UNITED STATES PATENT AND TRADEMARK OFFICE

Office Action Summary	Application No. 10/049,834	Applicant(s) SCHEIBE ET AL.	
	Examiner Jason J. Boeckmann	Art Unit 3752

DETAILED ACTION

Claims 1-37 are rejected, as best understood, under 35 U.S.C. 103(a) as being unpatentable over Baumgartner et al. (6,161,813), In view of Kilgore et al. (5,636,827).

Examiner's Marked Up Figure #3

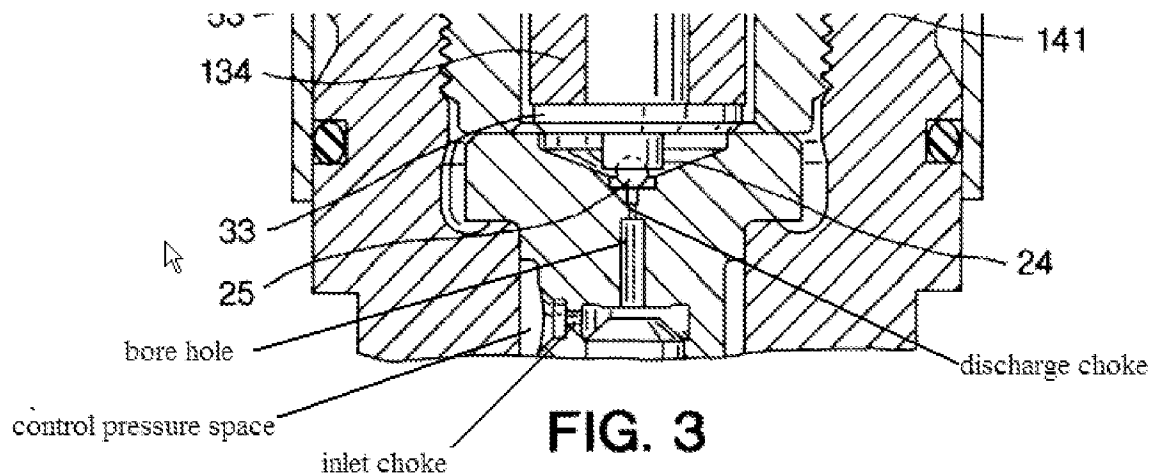
Regarding claims 14-19, and 31-37 the insert part (also forms a stop for the valve needle) is formed in two parts with a first part, which contains an opening for the passage fluid and a discharge or outlet choke (see examiners marked up figure 3) and a second part at the control pressure space side, with a bore hole (see examiners marked up figure 3) which connects the control pressure space (see examiners marked up figure 3) with an opening for the passage of fluid. The second part contains an inlet choke (see examiners marked up figure 3) near the bore hole (see examiners marked up figure 3). The pressure space is connected with an inlet choke and the rear end of the valve needle (see examiners marked up figure 3) averted from the nozzle needle

seat surface lies in the control pressure space. The pressure insert part also including an inlet choke and an outlet or discharge choke (see figure below).

Regarding the applicant's arguments concerning claim 16, it is noted that the sealing surface is formed in the end face of a disk shaped insert part, the first part of the insert is disc shaped. Secondly, the insert part does include an inlet choke and an outlet choke, see figure 3 above.
